# Access Compliance Report

## Public Rights-of-Way

Intersection ID: 28914	Main Street: PINEVILLE-MATTHEWS_RD	Cross Street: SPRINGBANK_LN	Location: NE
ADA ID: E2C9366C505B	Ramp Type: ParaDiag	Initial Pass/Fail: Fail	Overall Compliance: No
Severity Score: 26.25			
Codes/Mitigation Info/Possible Solution		Field Measurements/Component Compliance

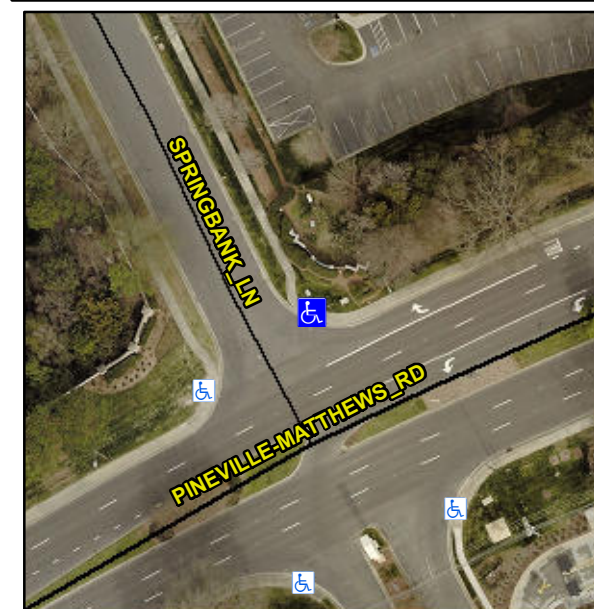
**DAMAGED DWS, LT RP < 5%**

**R304.5.3, R304.3.2**

**Remove & Replace Curb Ramp With Two New Directional Ramps or Equivalent.**
